Safety Review of Proposed Intersection of 'Spine Road' and Hurontario Street

Schedule 'C' Class Environmental Assessment for Widening of
McLaughlin Road and Construction of East-West Spine Road
(Mayfield West Phase 2)

TPB166090

Town of Caledon

HWY 410 INTERCHANGE
 CLASS ENVIRONMENTAL ASSESSMENT
 TOWN OF CALEDON
 FIGURE B-1 EASTBOUND/WESTBOUND
 NATURAL TRAVEL PATH OVERLAP

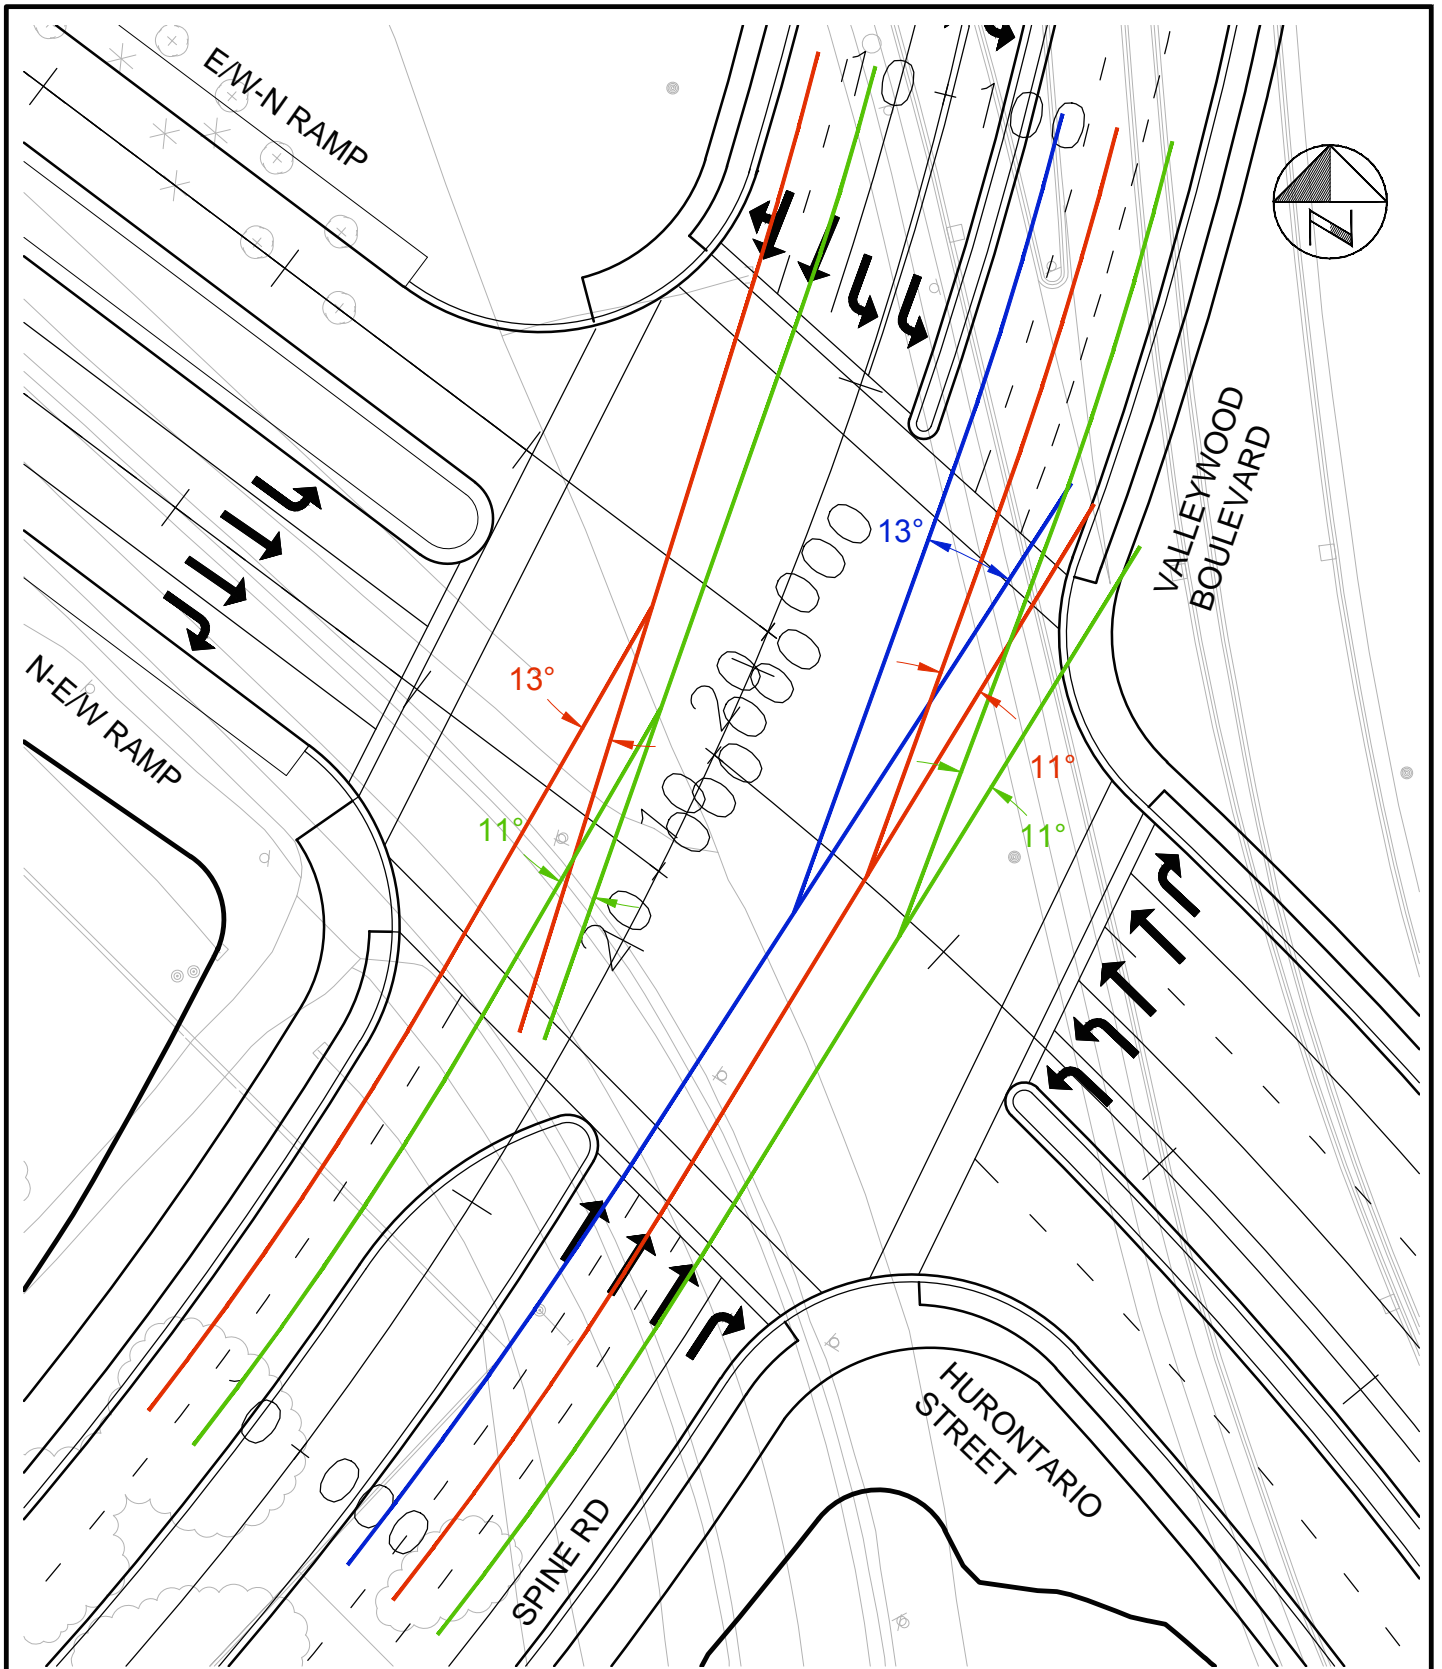
The natural linear travel paths for vehicles heading both eastbound and westbound through the intersection are aligned away from the receiving lanes, with eastbound traffic naturally directed to the outside curb lane, and westbound traffic naturally directed towards the median. This misalignment results from the intersection's location along a relatively small radius curve (250 m). The average angle of offset for both northbound and southbound vehicles is 12 degrees. With the significant travel distance through the intersection, this misalignment could result in vehicles inadvertently switching lanes – resulting in frequent side-swipe collisions. A diagram illustrating the natural paths for the subject movement is provided as Figure B-1 in **Appendix B**.

Strategy		Potential Impacts and Limitations	Anticipated Effectiveness
1	Addition of skip lines to direct traffic to appropriate receiving lane.	Strategy is only considered effective if line work is clearly visible, requiring ongoing restriping and dry pavement conditions.	Low
2	Increase radius on curve to the extent possible on Spine Road and add skip lines to direct traffic to appropriate receiving lane.	Strategy partially addresses the misalignment of lanes, reducing the average offset angle between the natural path and receiving lanes by >4 degrees. However, the eastern limit of the increased horizontal curve would then be coincident with the vertical curve southwest of the bridge. In terms of skip lines, pavement markings are only considered effective if line work is clearly visible, requiring ongoing restriping and dry pavement conditions.	Moderate
3	Relocate intersection to linear section of the proposed Spine Road to such that intersection is no longer located on a curve.	Strategy would fully address misalignment of receiving lanes; however, would have significant impacts to properties located in the southwest quadrant of the intersection.	High

Safety Issue (Number and Description)		Recommended Strategy
1	Eastbound / Westbound Natural Travel Path Overlap	Strategy 3: Relocate intersection to linear section of the proposed Spine Road to such that intersection is no longer located on a curve.
2	Southbound Left Intersection Sight Distance	Strategy 2: Dedicated Left-Turn Phasing.
3	Westbound Right Departure Sight Distance	Strategy 3: Eliminate curvilinear approach on Hurontario Street.
4	Southbound Right Departure Sight Distance	Strategy 3: Relocate intersection further west to move limit of departure sight distance southwest of interference with the bridge and ramp.
5	Weaving at W-E Ramp Connection from Valleywood Boulevard	Strategy 2: Drop one eastbound (Spine Road) lane before the intersection, and develop access lane for S-E Ramp beyond Hurontario Street.

HWY 410 INTERCHANGE
 CLASS ENVIRONMENTAL ASSESSMENT
 TOWN OF CALEDON
 FIGURE B-2 SOUTHBOUND LEFT
 INTERSECTION SIGHT DISTANCE

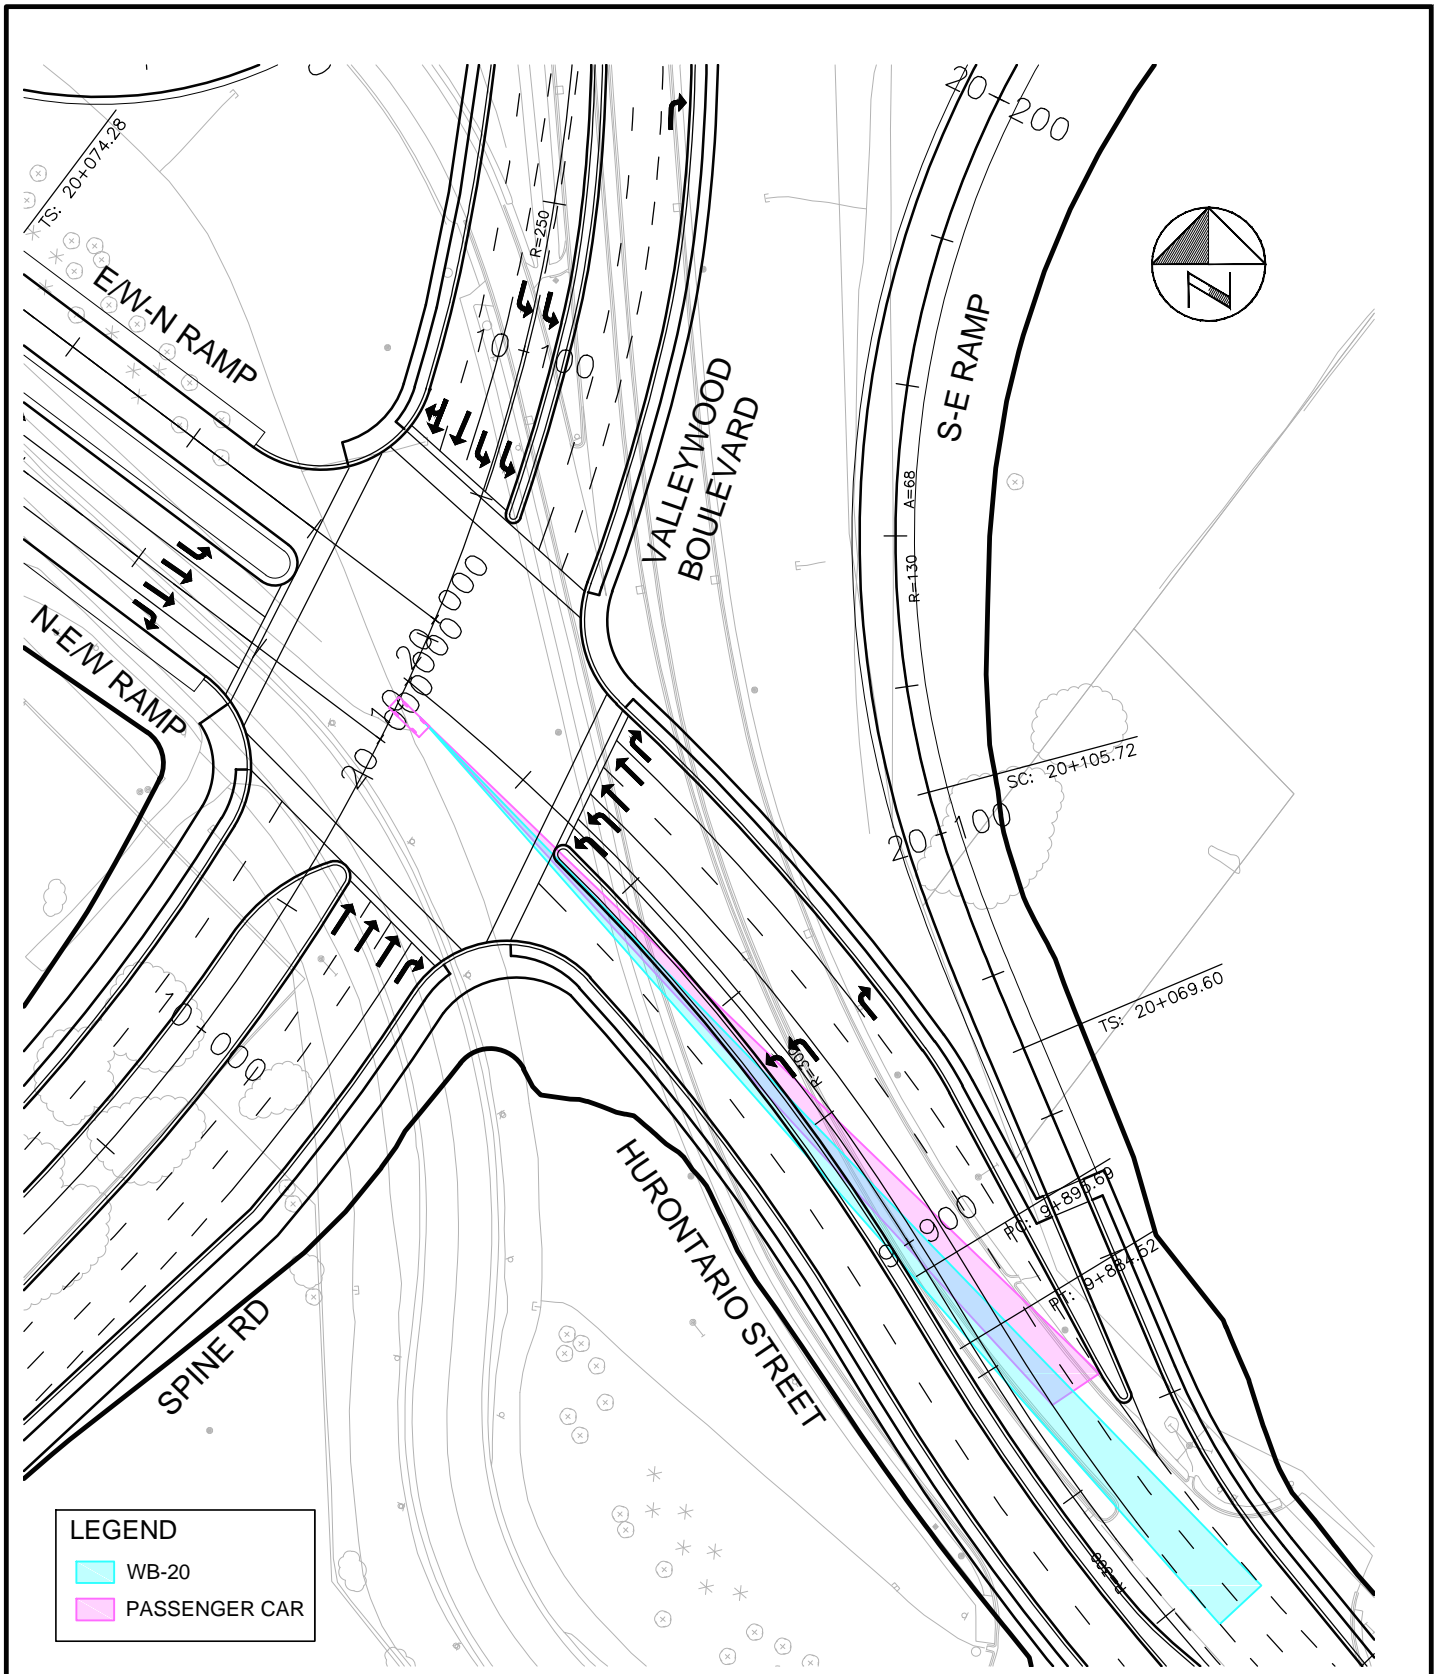
Assuming the intersection does not have dedicated left-turn signals, sight distances for the southbound left are inadequate given visual conflicts with the dual opposing lefts and the curvilinear alignment of the westbound lanes. Sight distances for the subject movement are illustrated in Figure B-2 in Appendix B.

Strategy		Potential Impacts and Limitations	Anticipated Effectiveness
1	Realign southbound left turn lane into the available median space, aligning the inside edge of the turn lane more closely to outside limit of the northbound lanes. Would require addition of a painted gore area between the left turn lane and the through lanes.	While mitigating issues associated with visual conflict with the northbound left turn lanes, sight distances issues related to the curvilinear alignment of Hurontario Street continue to be an issue.	Low-Moderate
2	Dedicated Left-Turn Phasing	Impact on traffic operations should be confirmed.	High
3	Straighten northbound approach on Hurontario Street and realign southbound left turn lane into the available median space, aligning the inside edge of the turn lane more closely to outside limit of the northbound turn lanes,	Strategy would address visibility issues for left turning vehicles, but would require property acquisition. Potential issues with constructions staging.	High

HWY 410 INTERCHANGE
CLASS ENVIRONMENTAL ASSESSMENT
 TOWN OF CALEDON
FIGURE B-3 WESTBOUND RIGHT
DEPARTURE SIGHT DISTANCE

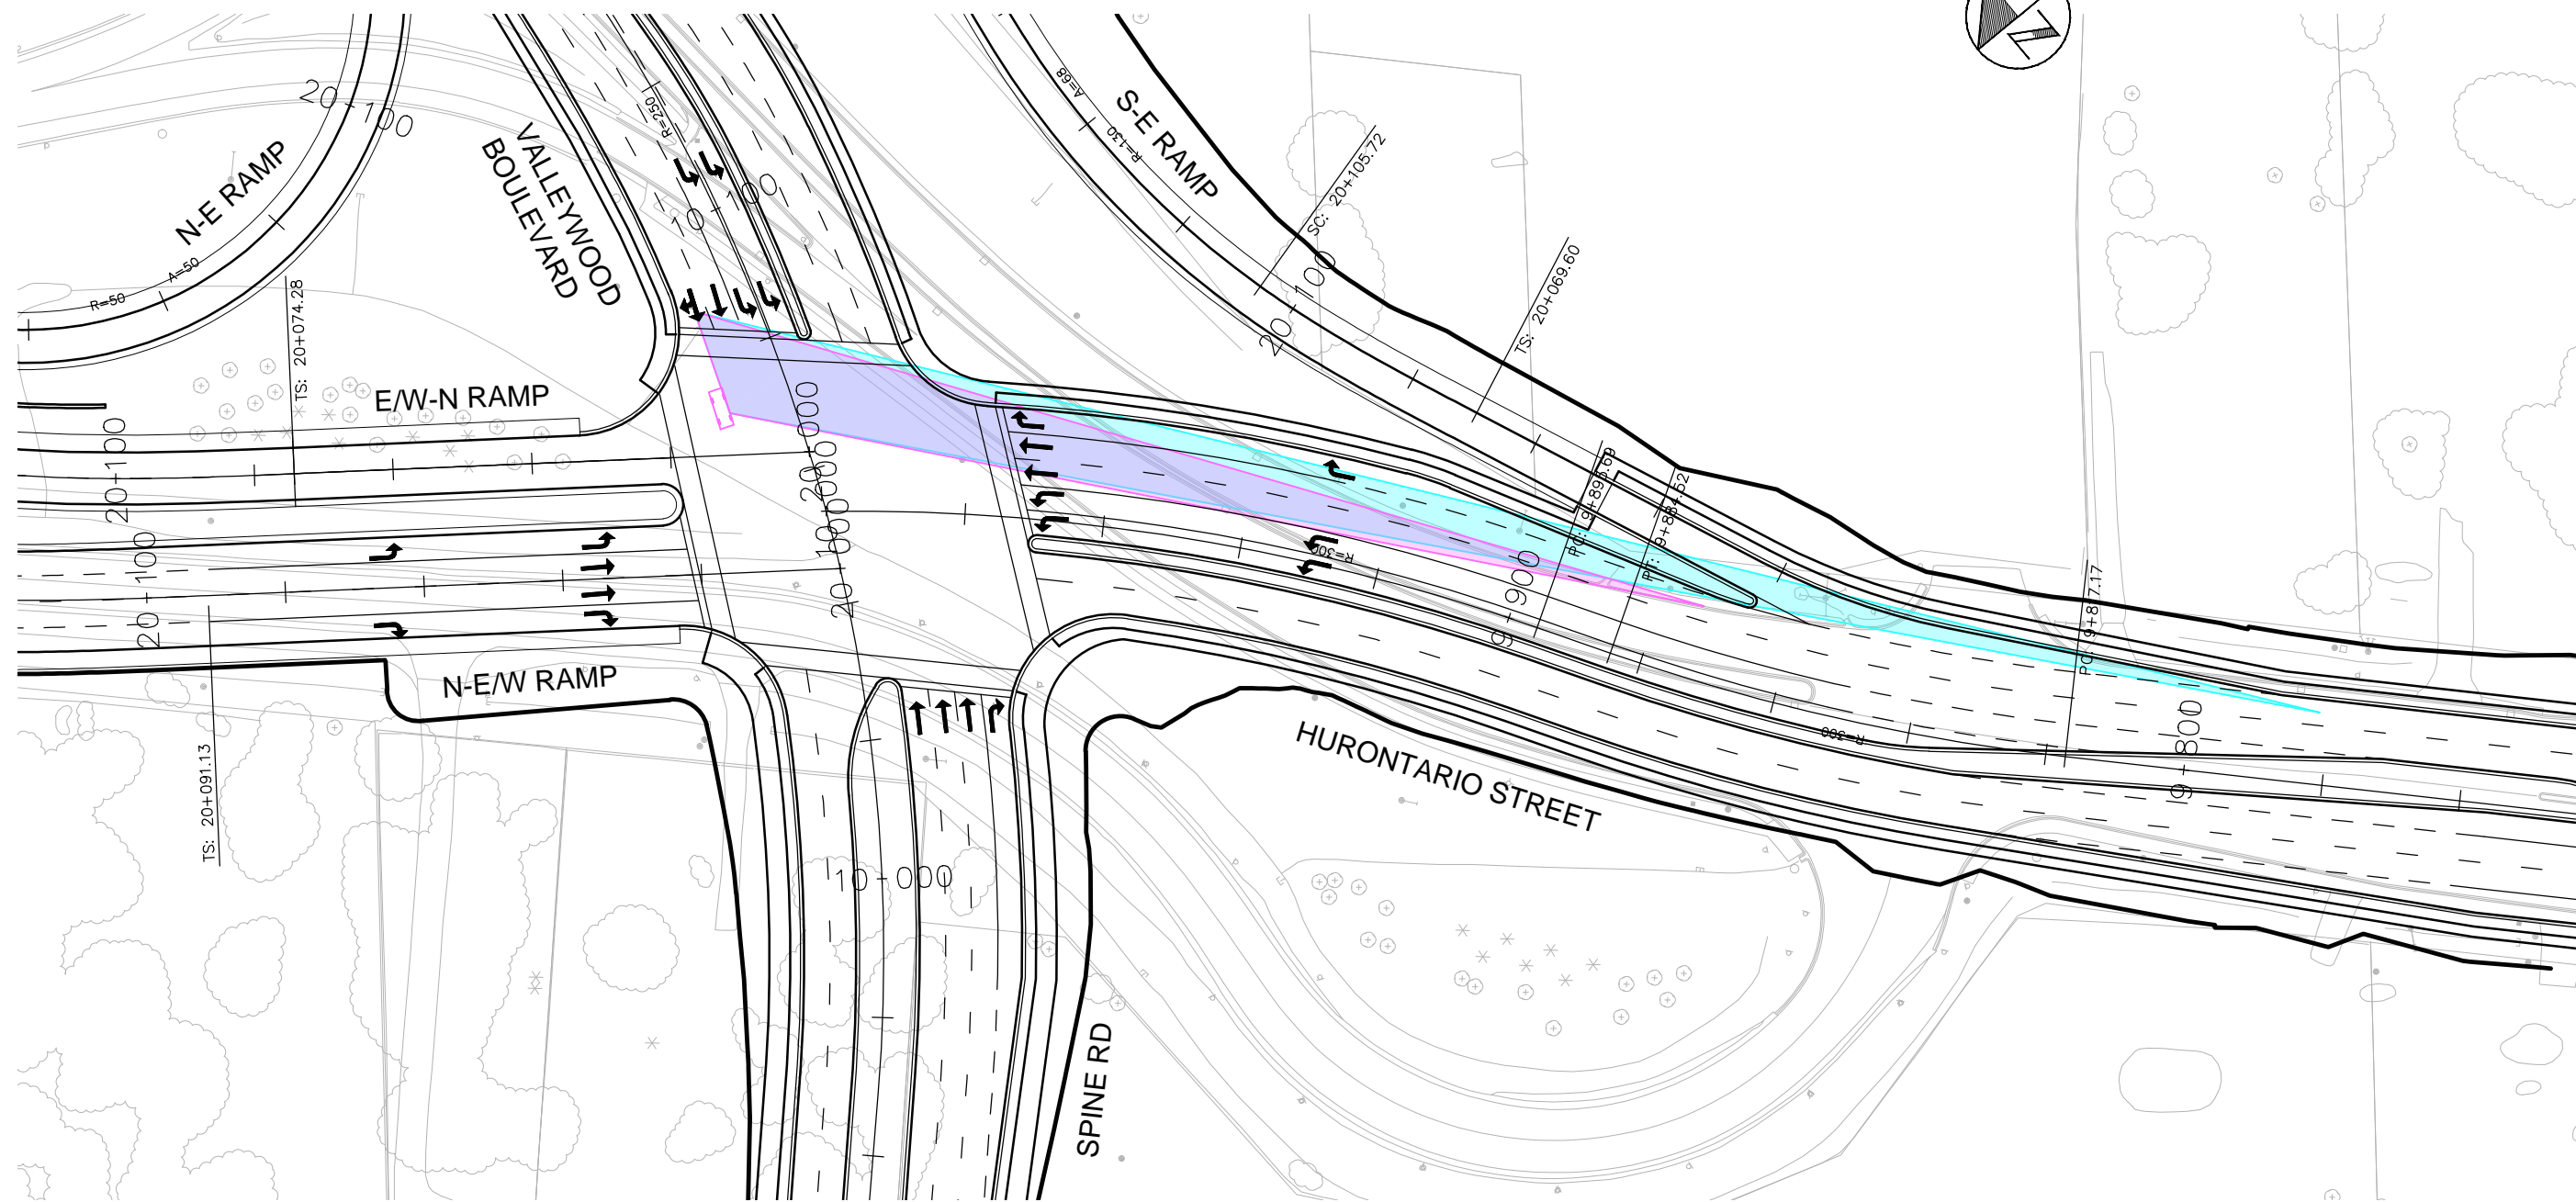
Decision sight distance for the westbound shared through-right (Valleywood Boulevard) is impeded partially by the northbound inside through and outside left turn lane due to the curvilinear alignment of the Hurontario Street approach. Details regarding the vertical and departure sight distances for this particular movement are summarized in Table 7. Diagrams illustrating the departure sight distance triangles for the subject movement are provided as Figure B-3 in **Appendix B**.

Design Vehicle	Driver's Eye Height (m)		Departure Sight Distance and Station	Vertical Sight Distance Acceptable		Departure Sight Distance Acceptable
	TAC	MTO		TAC	MTO	
Passenger	1.08 m	1.08 m	145 m (~STA 9+874)	Yes	Yes	No
WB20	2.40 m ¹	2.33 m	235 m (~STA 9+782)	Yes	Yes	No

Strategy		Potential Impacts and Limitations	Anticipated Effectiveness
1	Introduce 'Right on Red' restrictions.	If adhered to, would eliminate collision risks.	Moderate
2	Eliminate the westbound right turn and provide westbound access at the existing Valleywood Boulevard loop ramp.	Suitability of providing either a dedicated left or shared left-through at the W-W loop ramp (existing) will need to be examined by the design team. Traffic flow implications should also be considered.	Moderate-High
3	Eliminate curvilinear approach on Hurontario Street.	Would eliminate visual conflict with through and turning lanes. Would require property from private landowners.	High
